FL804AB

REVISED NOTICE

Subject: TBB Saf-T-Liner C2 Power Ports

Models Affected: Specific Model Year 2019-2020 Thomas Built Buses Saf-T-Liner C2 school buses and non-school buses manufactured January 1, 2018, through November 21, 2018, with an optional auxiliary outlet powered by the ignition and accessory power circuits.

Figure 8: Completed Wiring Connections

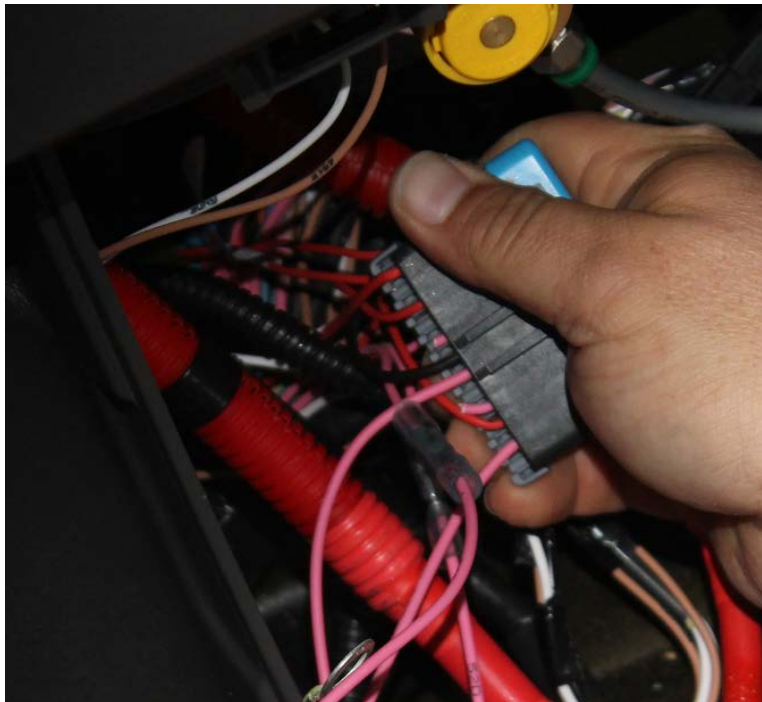
REVISIONS: In the *Auxiliary Port and PV360 Harness and Label Installation* procedure, see updated steps 7, 8, and 12.5. Please review.

7. Push the terminal of wire 52B_2 (from new harness TBB 221296) into Position 'G' until it locks into place.
8. Cut the wire in Position 'J' and put a cap or sealing butt splice on the wire coming out of the plug. See **Figure 6** for location of Position 'J.'
9. Take the remaining wire cut off from plug Position 'J' and connect it to 52D_1 from harness TBB 221296.
10. Push wire 52D_2 into the terminal at Position 'L' until it locks into place. See **Figure 7**.
11. Reinstall the gray wire "keeper" on the back side of the plug. See **Figure 8** for final installation.

Figure 9: Battery Wire Installation

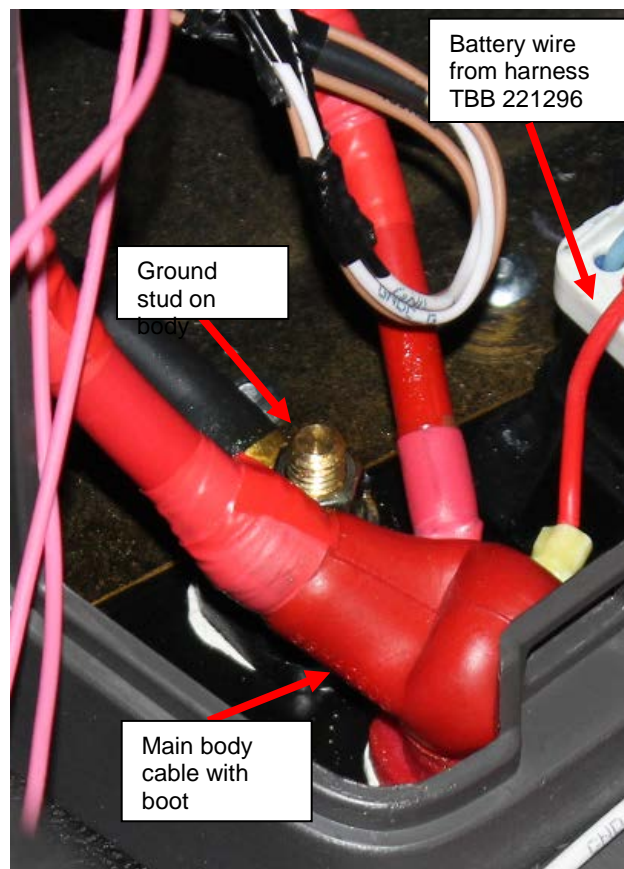
- 12.4 Attach the red wire with the ring terminal from harness TBB 221296 to the battery cable connection. Reinstall cables previously removed.
- 12.5 Tighten the nuts on the battery ground cables 140-150 lbf-in.
- 12.6 Pull the boot back over the battery cable. See **Figure 9** for final power cable installation.
